PLANNING BOARD

Tuesday, October 10, 2023 at 4:30 PM
Room 24 (Basement Level of City Hall)
and Zoom

To: Chair Mazer & Members of the Planning Board
From: Nell Donaldson, Director of Special Projects
Date: October 6, 2023
Re: Draft Text Amendments to the Land Use Code Under LD 2003
Meeting Date: October 10, 2023

L2

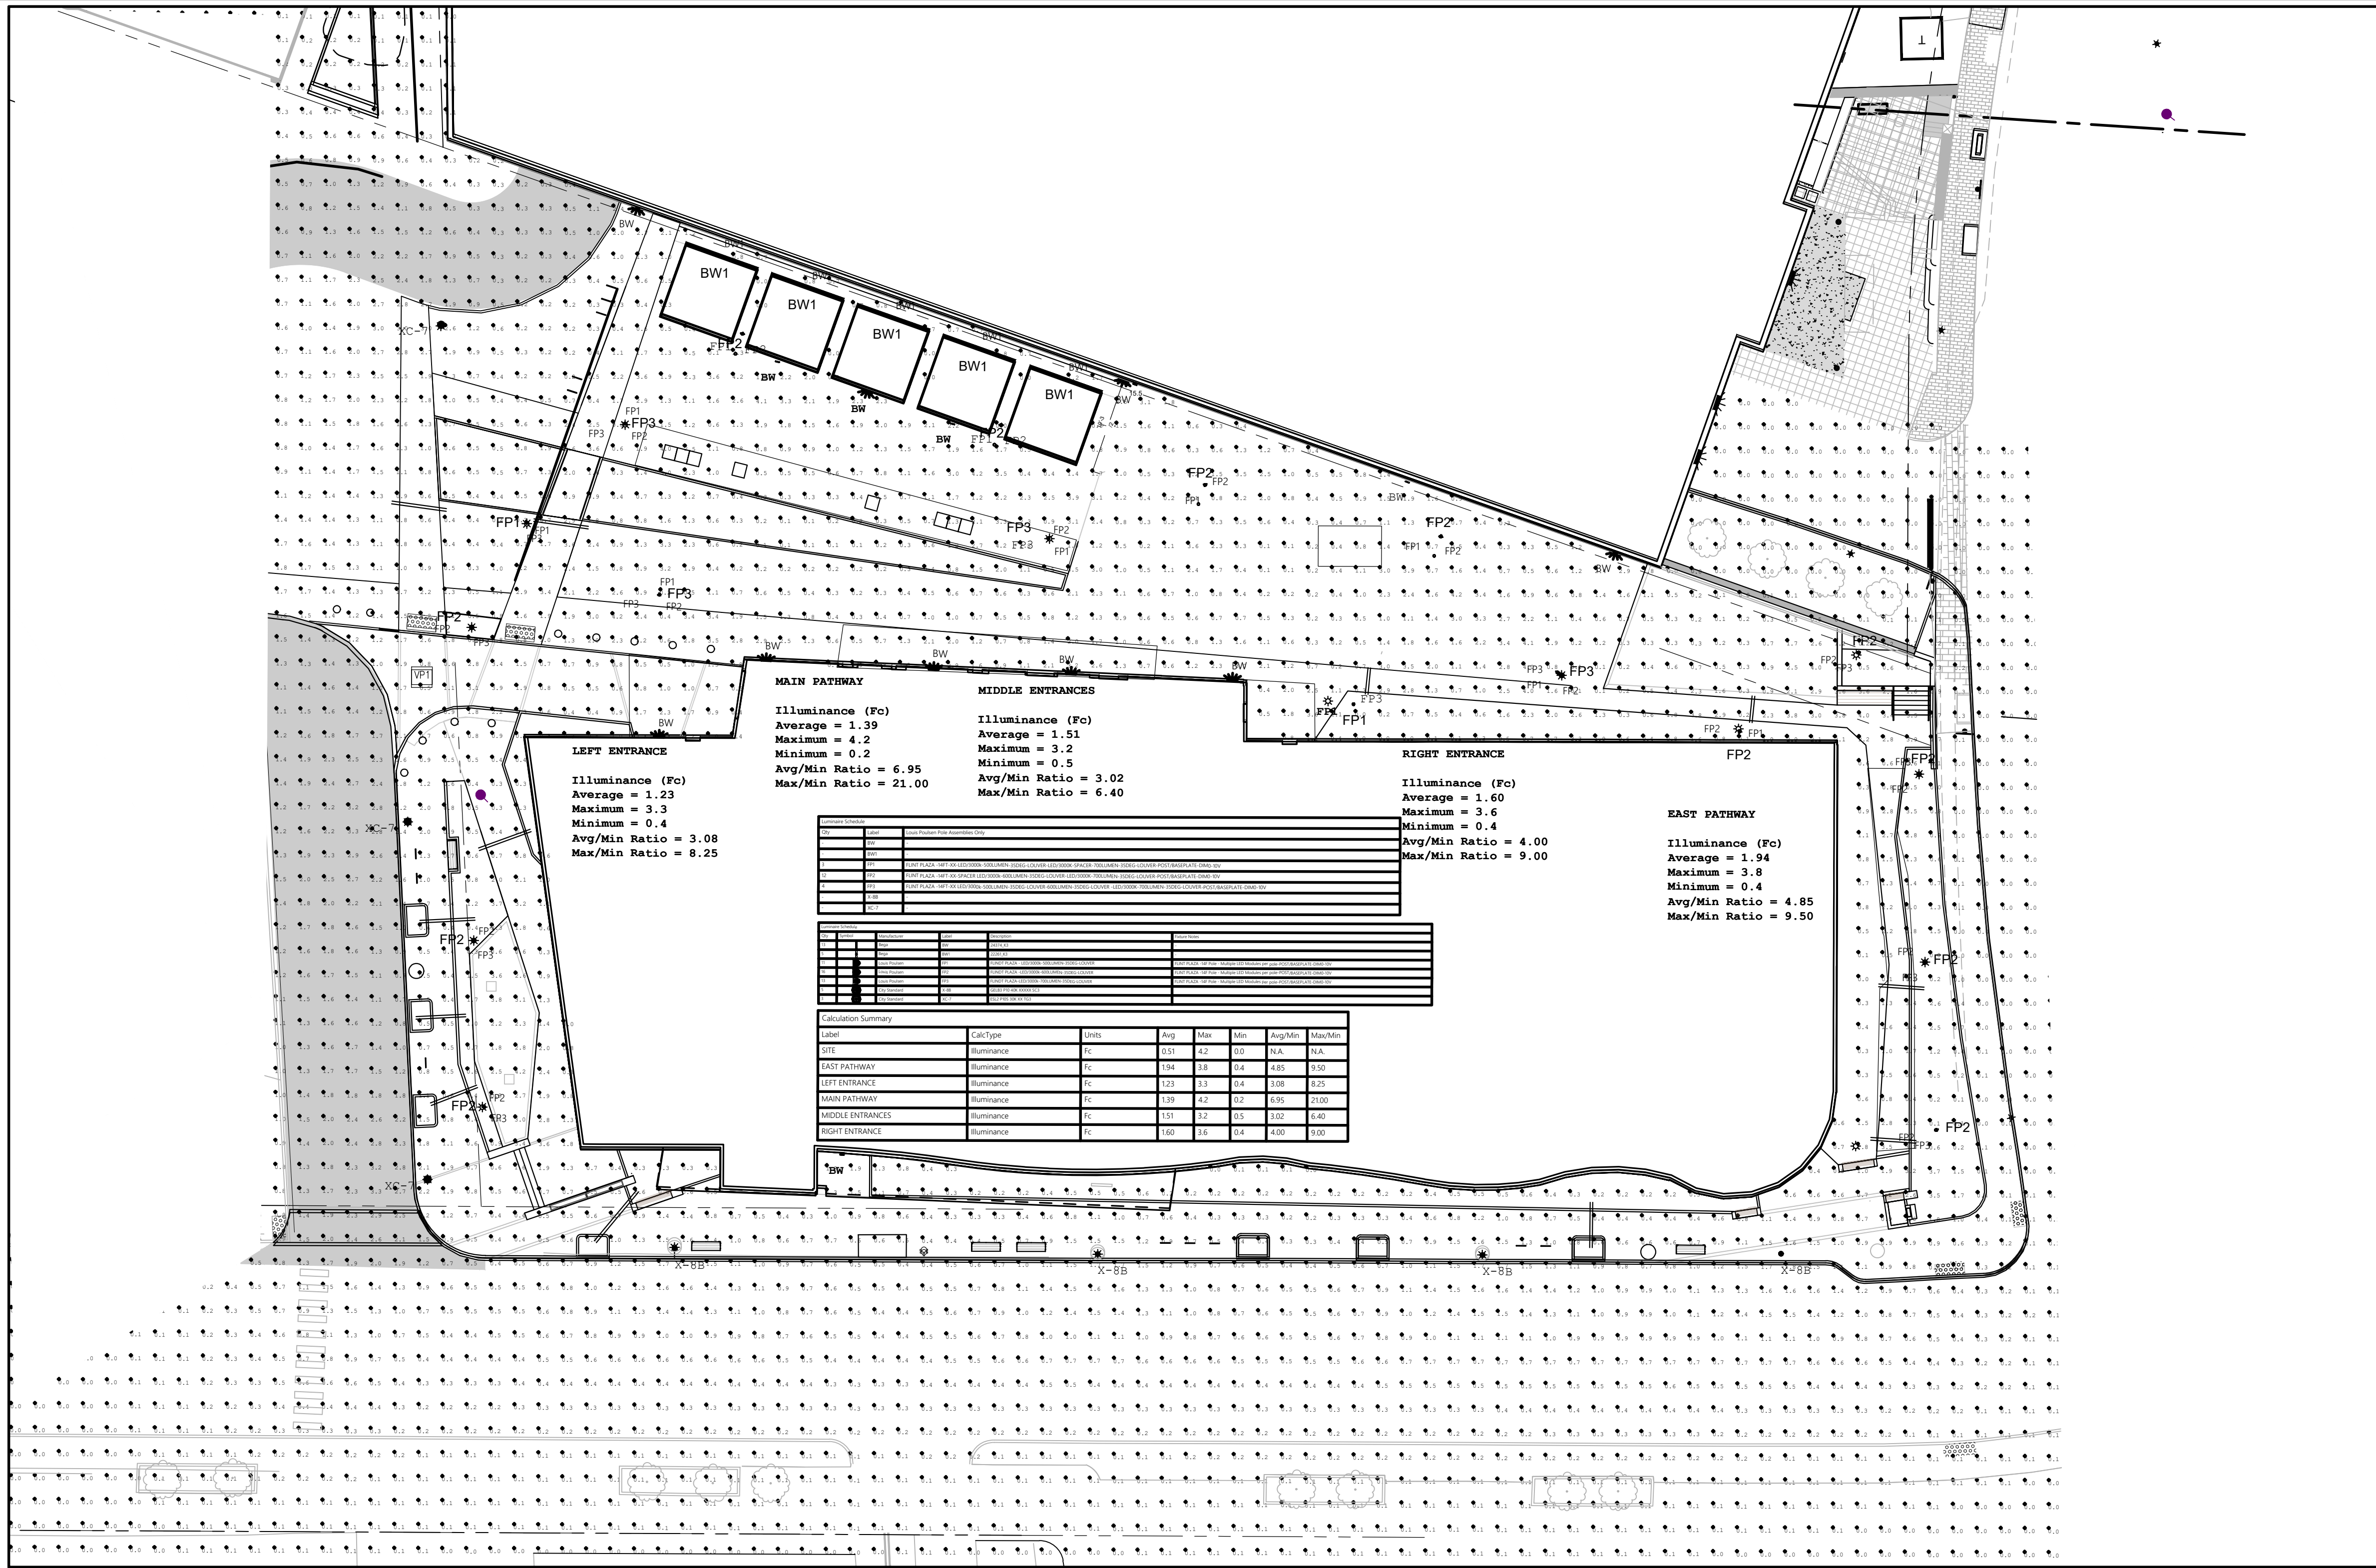
30. *Sheet L2 current landscape plan proposes numerous Maples as street trees. Maples as a genus are currently very over-represented in the City's street tree canopy. The City Arborist would prefer to see non-maples being planted on Thames to increase the Portland's urban canopy resilience against pests and disease. Tulip Poplars could be a good choice for the Thames Street frontage.*

- 30. Sheet L2 current landscape plan proposes numerous Maples as street trees. Maples as a genus are currently very over-represented in the City's street tree canopy. The City Arborist would prefer to see non-maples being planted on Thames to increase the Portland's urban canopy resilience against pests and disease. Tulip Poplars could be a good choice for the Thames Street frontage.*

- Sheet L2 current landscape plan proposes numerous Maples as street trees. Maples as a genus are currently very over-represented in the City's street tree canopy. The City Arborist would prefer to see non-maples being planted on Thames to increase the Portland's urban canopy resilience against pests and disease. Tulip Poplars could be a good choice for the Thames Street frontage.
